CHANGE ORDER

Project Name: Parrot Cove Stormwater Improvements Project

Change Order Number: 02

C.O.#2 PLAN REVISIONS

CONCRETE ENDWALL DETAILS

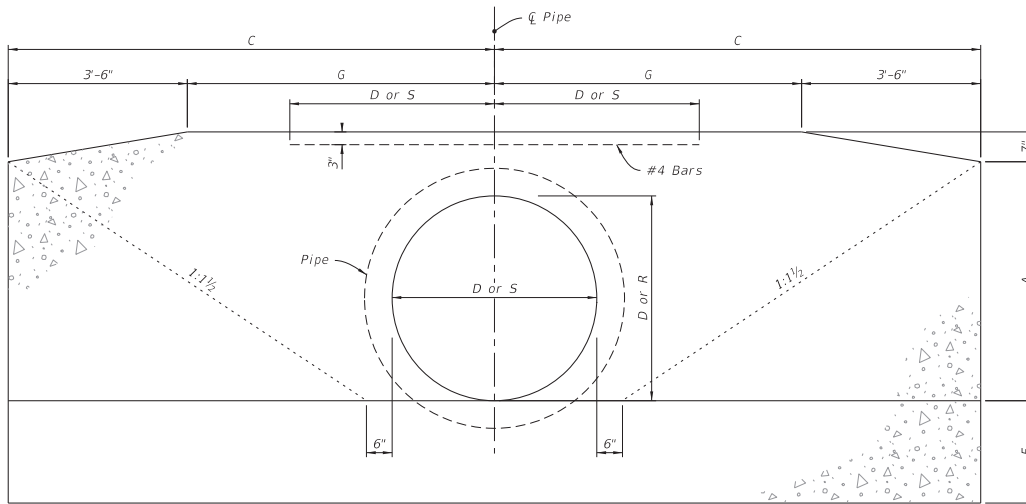
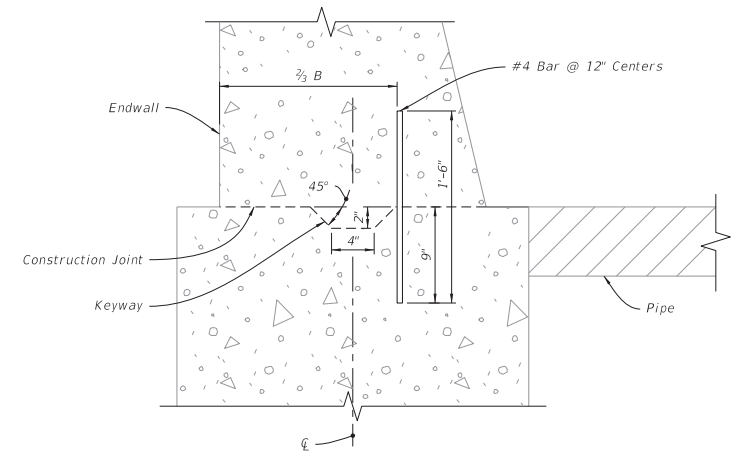
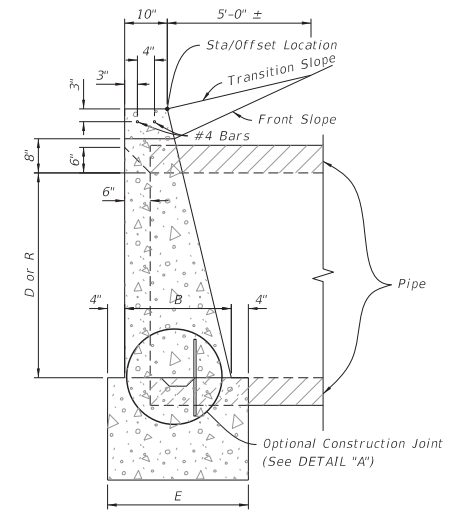
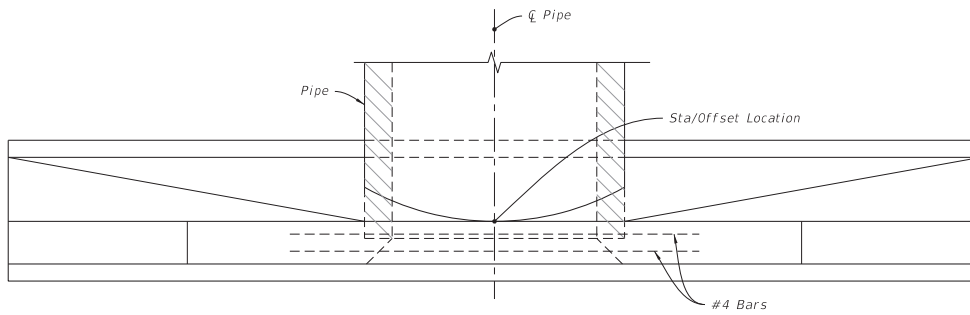
C.O. #2
4th Ave. N Location
48"x76" elliptical rcp
equivalent 60" round
